City of Canada Bay Submission to the draft Rhodes Precinct Place Strategy

City of Canada Bay Council submission to draft Rhodes Precinct Place Strategy

RE: PRCG Submission Rhodes Precinct Plan

Review of Draft Planned Precinct, Urban Design Report

Figure 187. Cavell Ave - Street Section

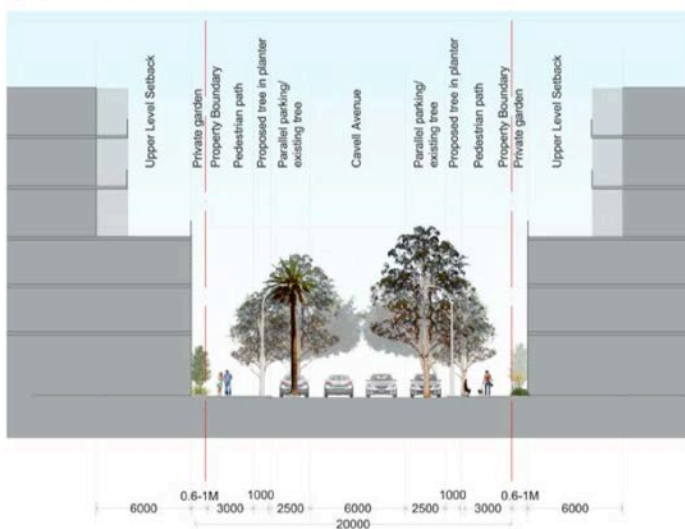
3.2 When we could make them safe for cyclists like this? (22.2m between building lines)
